Product Information

TOYOTA RAV4 (Front) : SM5639

February 2016

KYB shock absorbers 339031/32

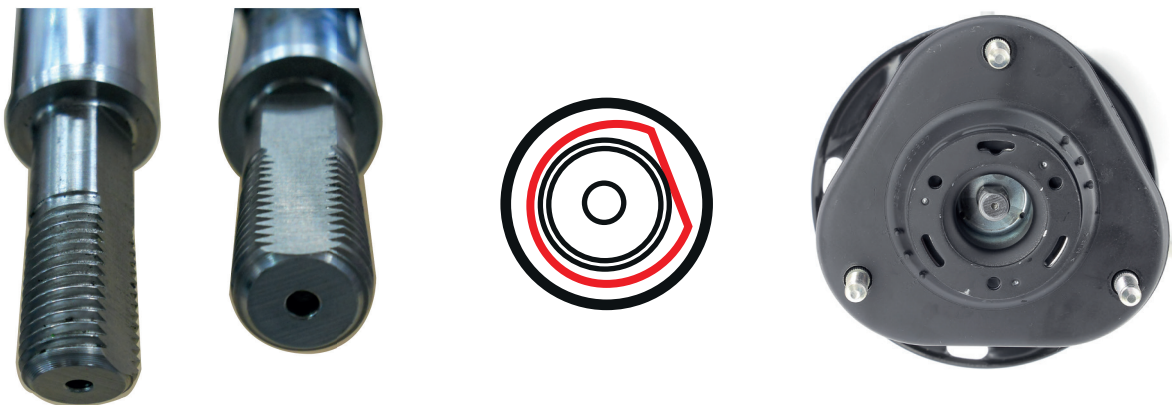
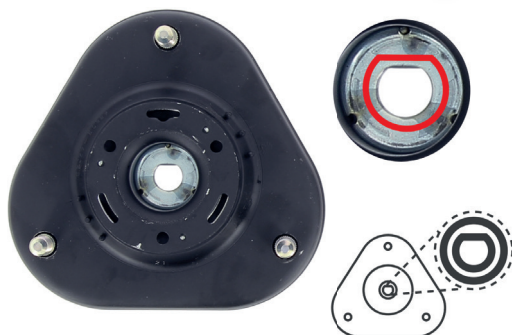
When you replace the strut mount, you must check the shape of the piston rod. KYB shock absorbers 339031/32 have a flat surface and the strut mount must reflect this. These flat surfaces lock the piston rod in the installation position, allowing you to tighten or remove the nut. So, if you use the wrong strut mount, you are not able to assemble the part correctly.

48609-0R010 & KYB SM5658
48609-42020
48619-0R010
48619-42010

48609-12500 & KYB SM5639
48609-12570
48609-42030
48609-42060
